Exelon Generation Company, LLC
Byron Station
4450 North German Church Road
Byron, IL 61010-9794

Byron Station, Units 1 and 2
Facility Operating License Nos. NPF-37 and NPF-66
NRC Docket Nos. STN 50-454 and STN 50-455

Subject: Submittal of 2008 Byron Initial License Examination Post-Examination
Comments

Enclosed are the post examination comments for the 2008 Byron Initial License
Examination administered May 30, 2008.

Operator rounds printout (supplied as attachment)

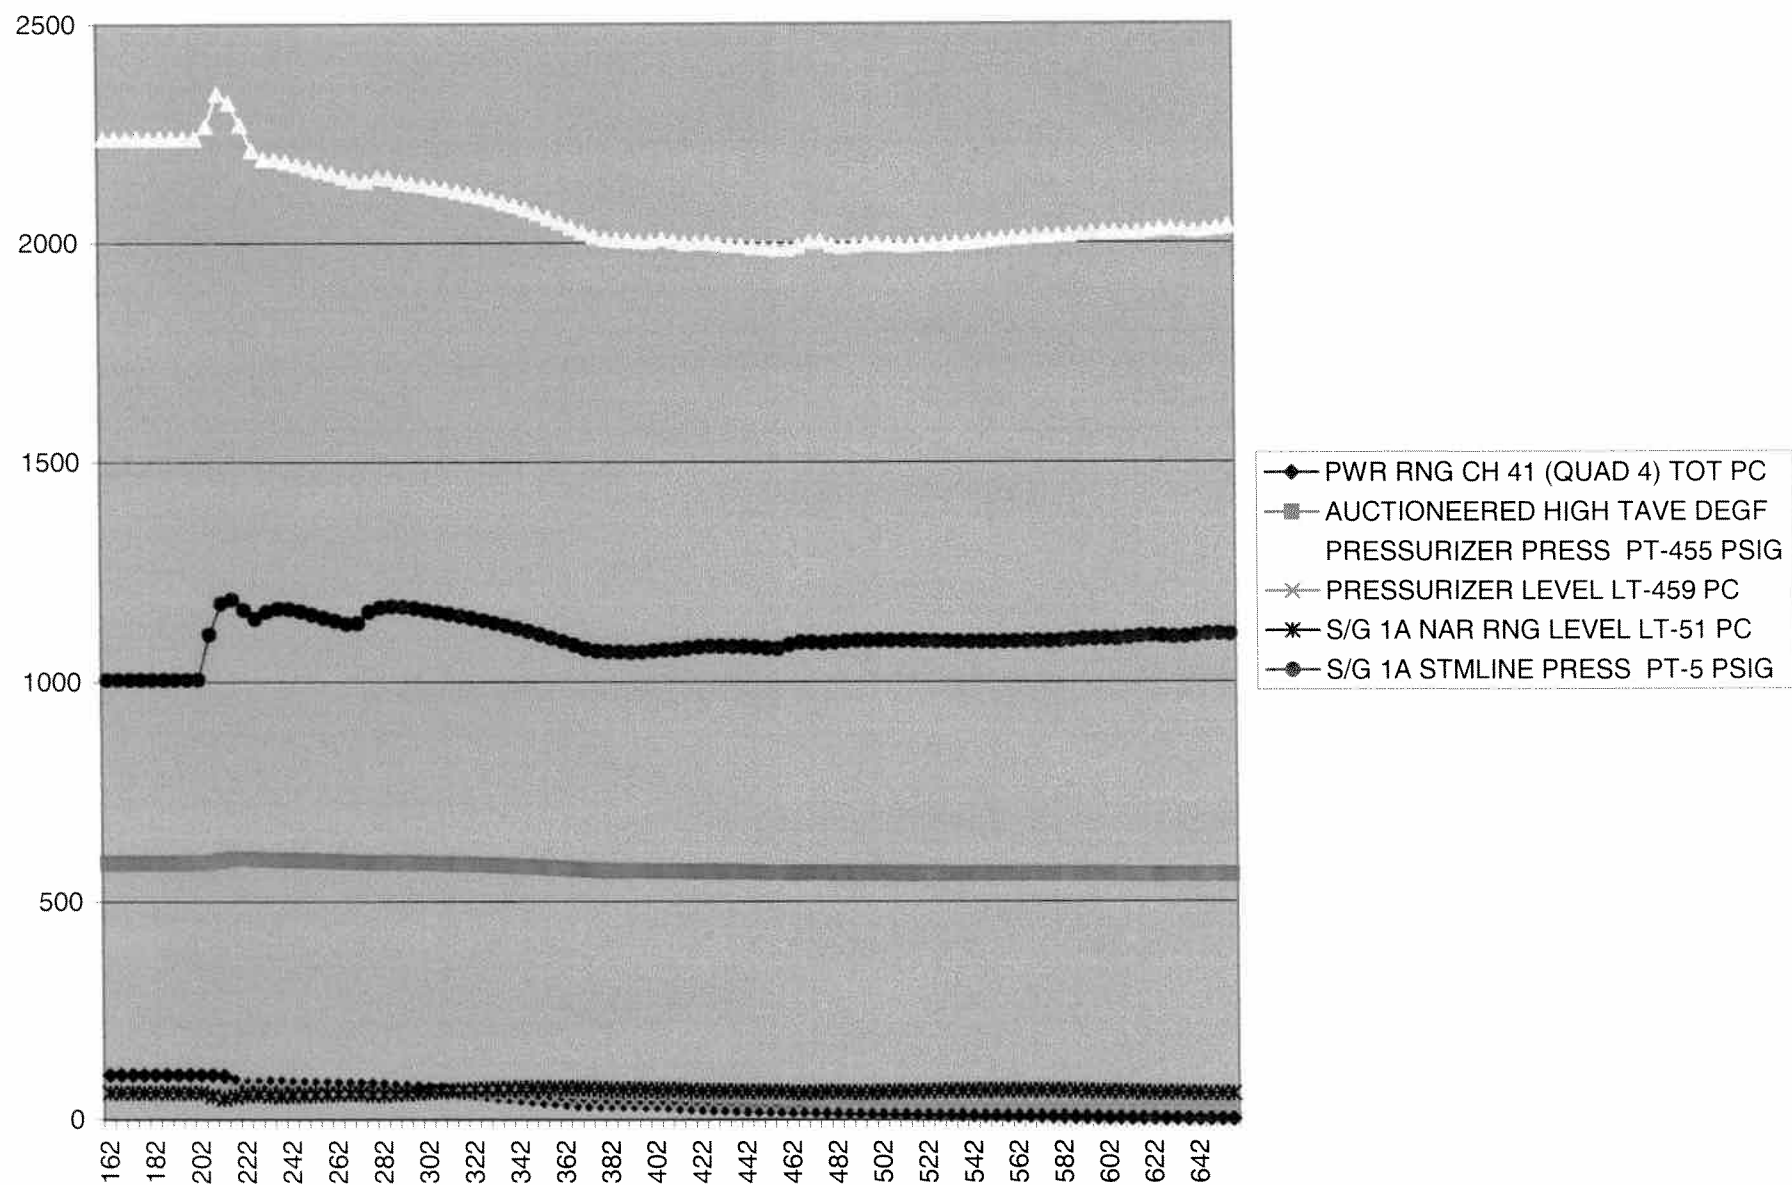
Operator rounds for DC bus 111 list a minimum value of 127.6 volts, and maximum value of 140 volts. Main Control Board alarm responses 1/2-21-E-10 for both Unit 1 and Unit 2 125V DC busses have alarm setpoints of $\leq 123V$ DC.

The stem of the question states that "Voltage on Bus 111 is 121 VDC".

This led the applicants to reject choice "a", "Parameters on Bus 111 are normal and within limits. No action is necessary." Bus 111 voltage is NOT normal and within limits; bus voltage is at least 6.6 VDC too low per the operator rounds and BOSR.

The licensee agrees with the applicants' comments. This question has no correct answer, should be deleted from the exam and the exam grading adjusted accordingly.
